ES_P89LPC903

Errata sheet P89LPC903

Rev. 02 — 4 May 2010

Fig 1. Flowchart ICP global erase

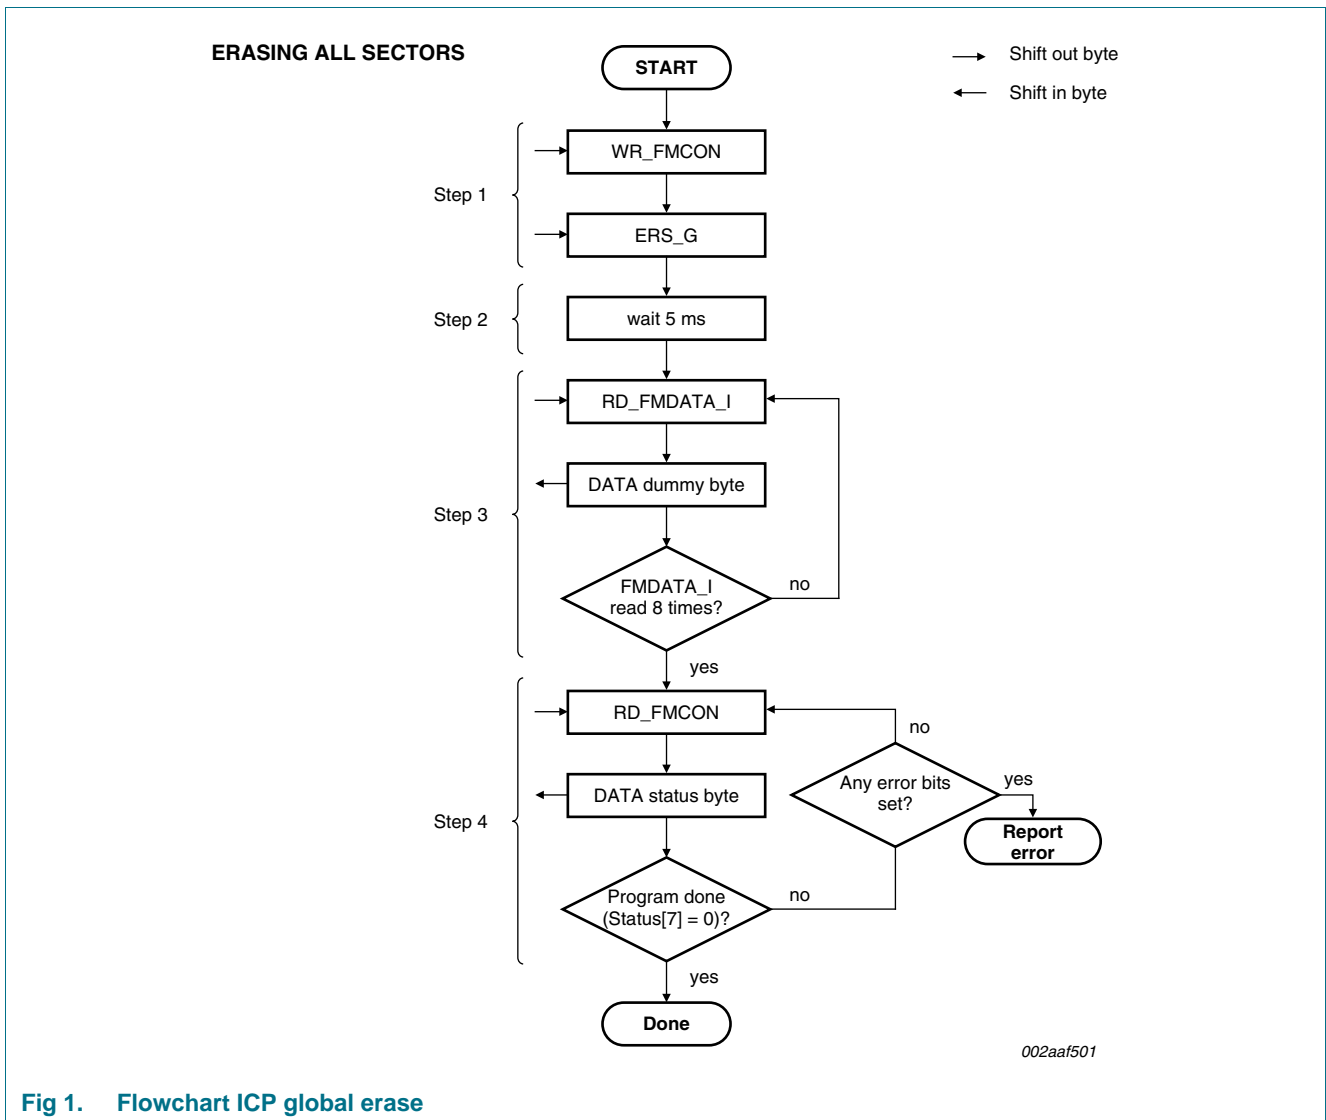
Problem:

When giving the Erase Global command through the ICP interface the P89LPC903 will not clear the busy flag and stay busy forever.

The workaround can be done in four steps:

Step 1: Shift out the WR_FMCON command followed by the Erase Global opcode.

Step 2: Wait 5 ms.

Step 3: Do 8 dummy reads with the RD_FMDATA_I command.

Step 4: Read FMCON until the busy flag gets cleared.

Please also see [Figure 1](#).
